AMENDED PLAN	
Ref.	A1

SHDC Planning & Development 02 JUN 2011 Ref: 0290-11

PROPOSED EXTENSION TO No. 6 SCOLDHALL LANE. SURFLEET.
SPALDING. LINCOLNSHIRE. PE11 4BJ.

REAR ELEVATION AS PROPOSED

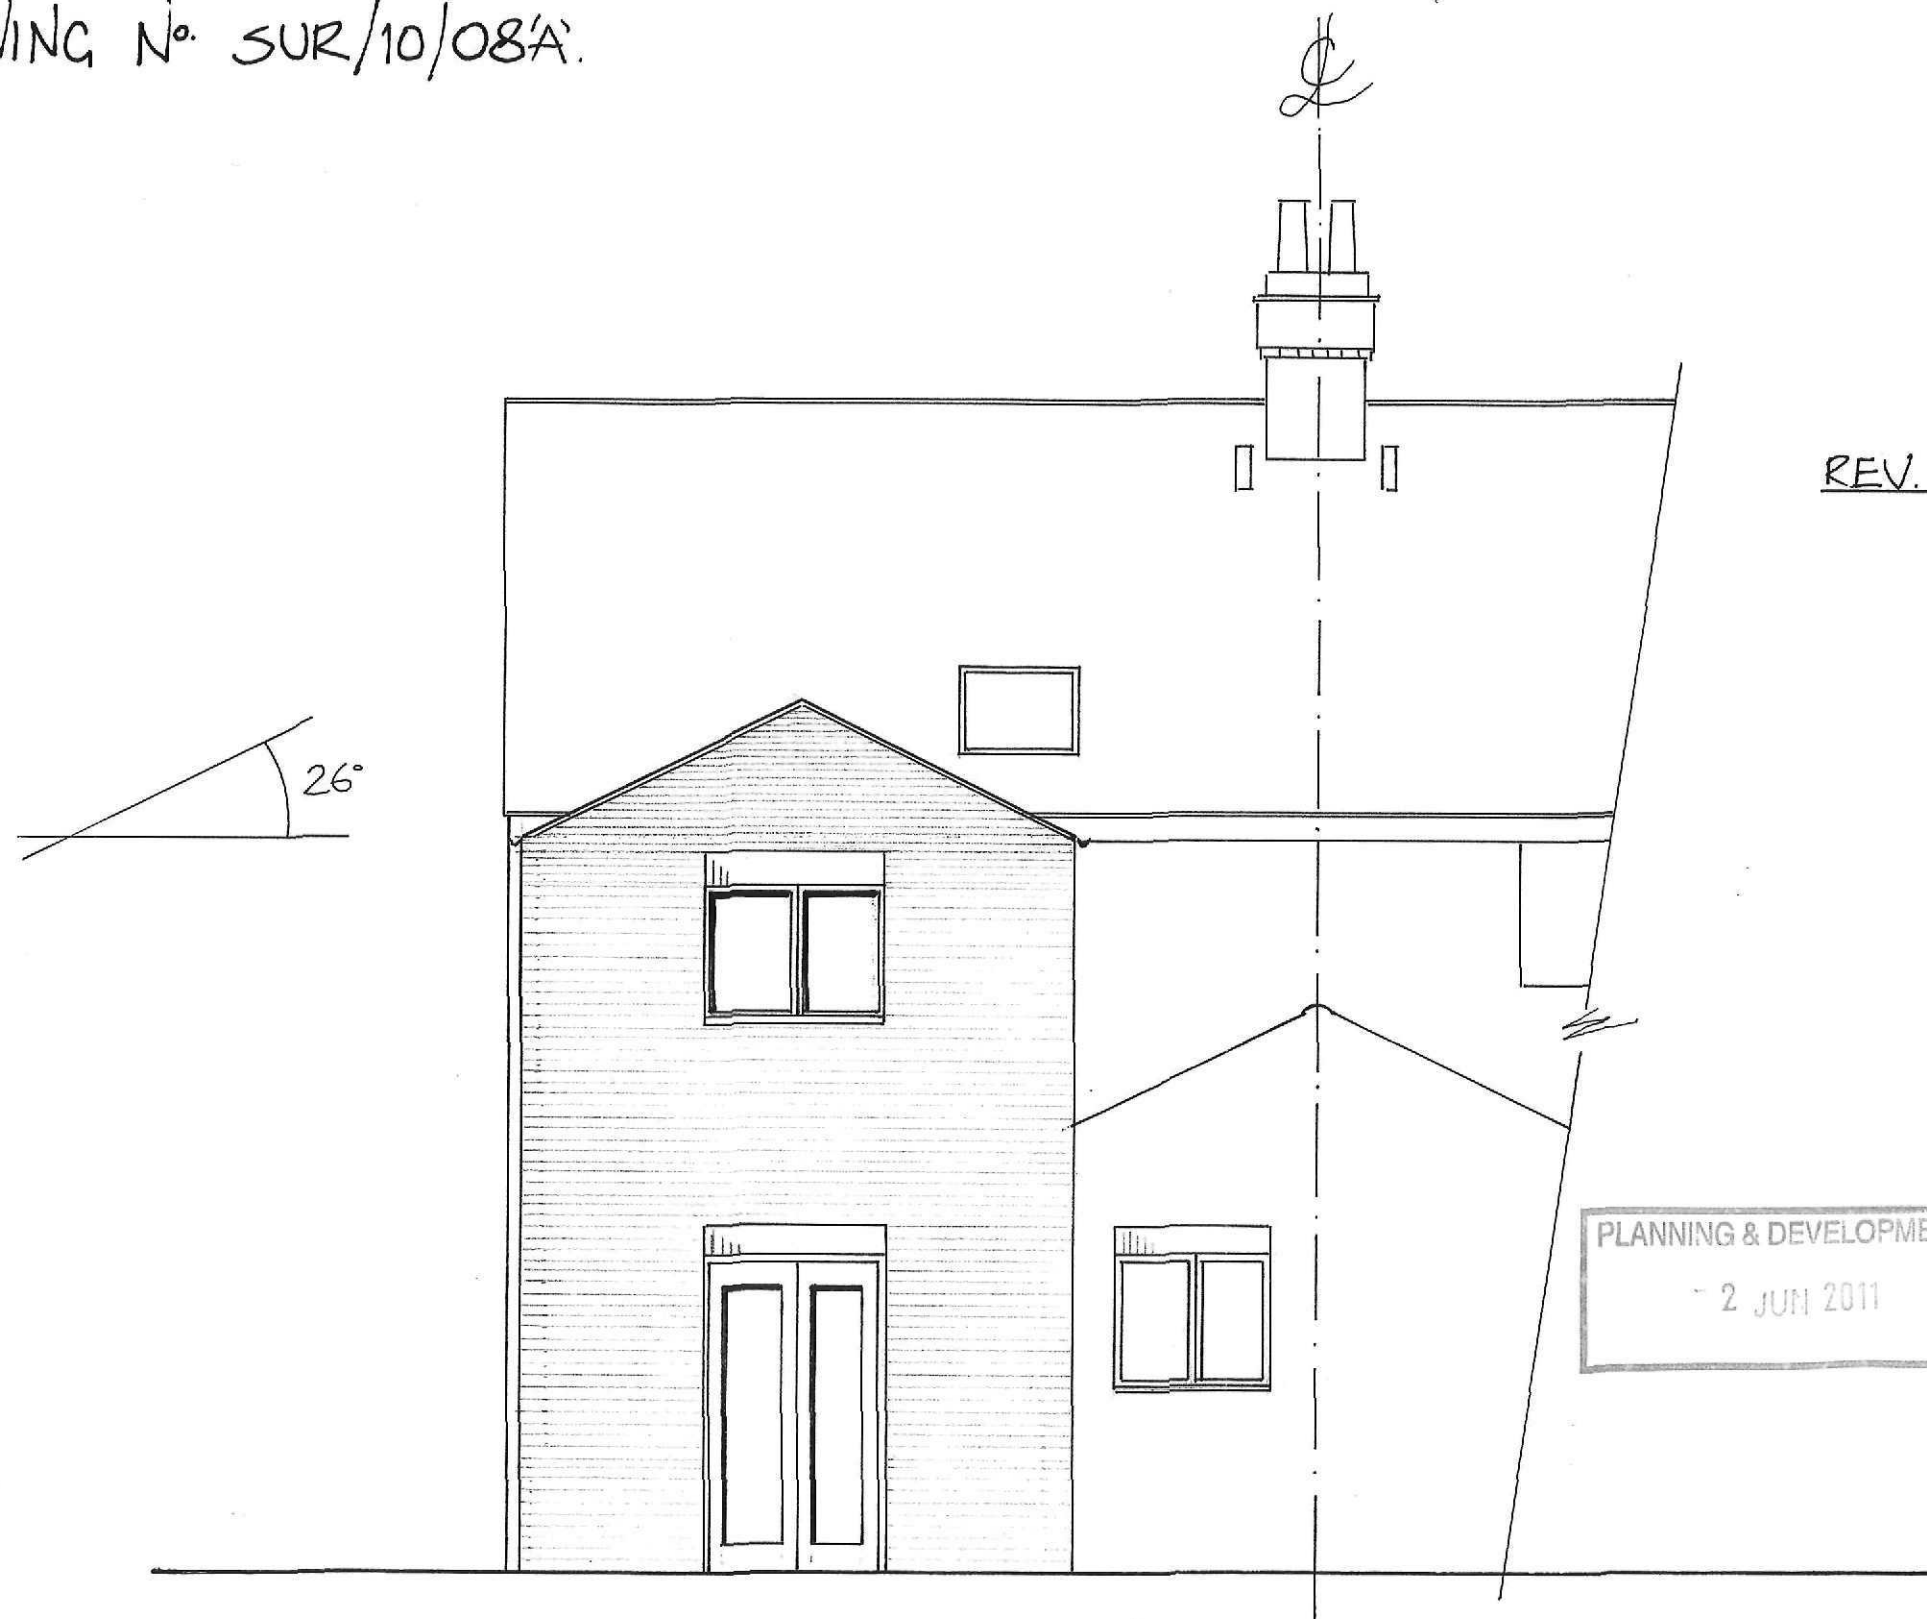
REV. 'A' ~ Addition of pitched roof as requested by S.H.D.C. (2/6/11).

- The pitched roof increases the original height by 1m. 26° is the same angle as the single storey extension & is the minimum pitch for slate.

- New Rooflight to be 780x980mm Skyview Energy 600 by Jeld-Wen UK.
